## Memorandum

Subject: Public Hearing and Consideration of a Variance from Section 5.5.F.5 (Median Openings) of the Burleson Design Standards Manual for a proposed development located on a portion of Abstract No. 178, Tract 7C, H.G. Catlett Survey, Johnson County, Texas located at the northwest corner of the intersection of SW Wilshire Boulevard and Lakewood Drive.

Re: QuikTrip Store #958  
Median Opening Variance on Lakewood Drive

### Exhibit A

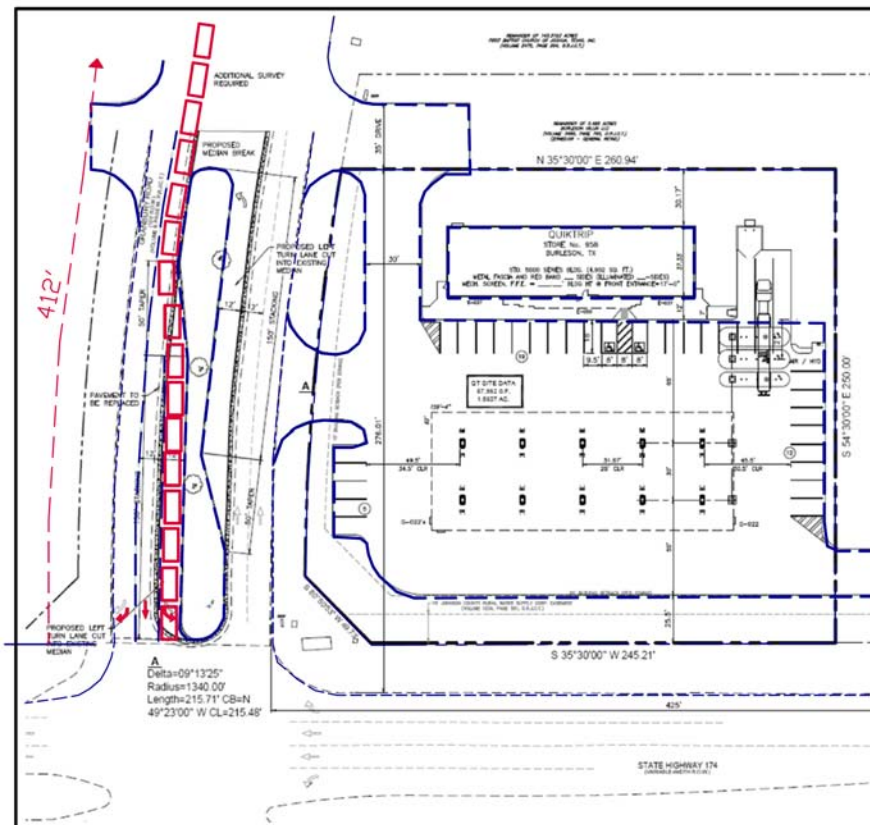
1. The Traffic Impact Analysis evaluated the queue lengths on Lakewood Drive at the signal. The analysis shows an unacceptable queue length if a single left-turn lane is used (Exhibit A) and an unacceptable intersection operation if a shared through/left-turn lane is used (Exhibit B). The most desirable layout in the future will be a dual left-turn lane at the signal.

**412' queue length with designated left turn lane.** This option is unacceptable because the vehicles in the queue block the median opening that serves the QT and the proposed Texas Health Resources complex. It is also important to note that the queue has backed into the Lakewood Drive through lanes.

**Exhibit B**

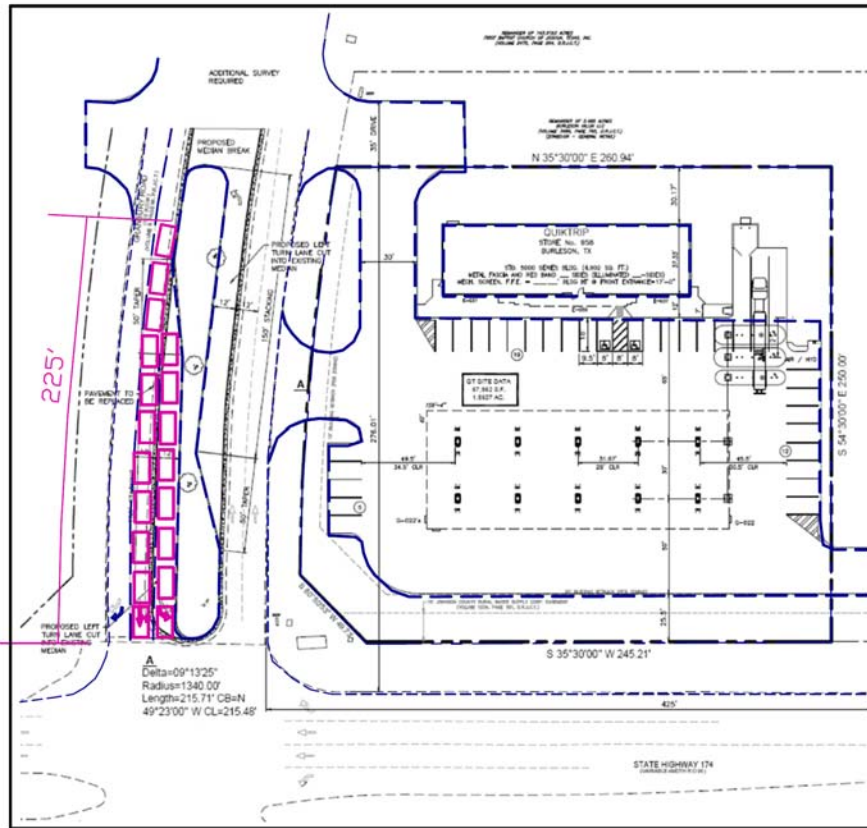
**225' queue length with shared through/left-turn lane.** This option is undesirable because the signal will be required to operate in a split-phase sequence as discussed later in this report.
